**PLANNING AND ZONING COMMISSION ACTION ITEM
STAFF SUMMARY
JULY 1, 2020 PLANNING AND ZONING COMMISSION MEETING**

**A RESOLUTION RECOMMENDING APPROVAL OF A LEVEL IV
DEVELOPMENT APPLICATION FOR A PUD LANDSCAPE PLAN FOR
THE MULTI-FAMILY PROJECT AT 14 ENSIGN DRIVE.**

The Town has received a Level IV Development Permit Application for a PUD Landscape Plan for the multi-family development at 14 Ensign Drive, more specifically described as Lot 1, Block 5, Corinthian Hill Subdivision. The applicant is Chills LLC. The Application is submitted to provide for site specific landscaping requirements, which deviate from the general landscape requirements found in the Dillon Municipal Code, through the Planned Unit Development review process. The submittal of the Application is in response to a condition of approval of the multi-family development on the site.

14 Ensign PUD Landscape Plan

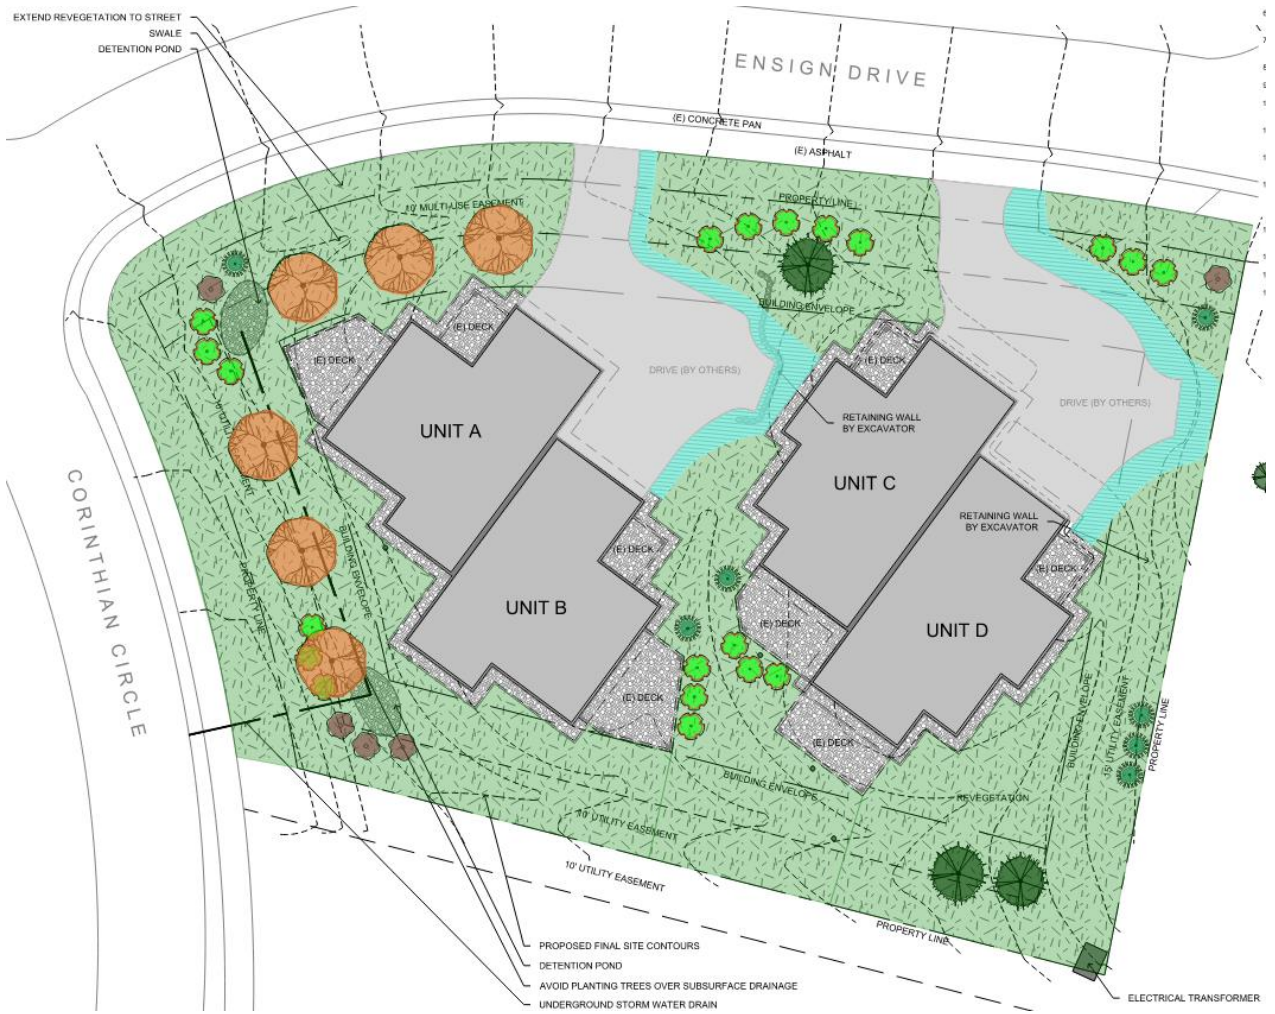
The application deviates from the general Code requirements by providing fewer evergreens and street trees. This is in response to the Corinthian Hill Property Owner's Association who asked the Applicant to provide a landscape plan that does not impact neighboring views of the lake and mountains by having too many tall growing evergreen trees. The Applicant has proposed Bristlecone Pine trees that are slow growing and do not have an excessive mature height. The other tree species provided is Spring Snow Crabapple which also do not grow very tall. The maximum mature height of a Bristlecone Pine is about 25 feet, and a Spring Snow Crabapple maximum mature height is about 20 feet. In contrast Colorado Spruce and Blue Spruce trees can grow up to 75-115 feet tall. Where the plan may lack in the total number of street trees, it more than makes up for that with the numerous additional shrubs of varying species: Chokecherry, Alpine Current, and Dwarf Artic Willow.

Snow Storage: The Code requires snow storage areas of not less than 25% of the hardscape snow removal area. The site has approximately 2,930 square feet of hardscape requiring snow removal. The PUD Landscape Plan shows a total of 877 square feet of snow storage provided, which is 30% of the hardscape area.

Off-Street Parking: Parking is provided in the garages of the units, as well as surface parking in front of the garages. There are two separate driveway cuts proposed, one for each of the two buildings. The Code requires off-street parking areas to be screened with landscaping. Landscaping is provided in the vicinity of the driveways to screen vehicles.
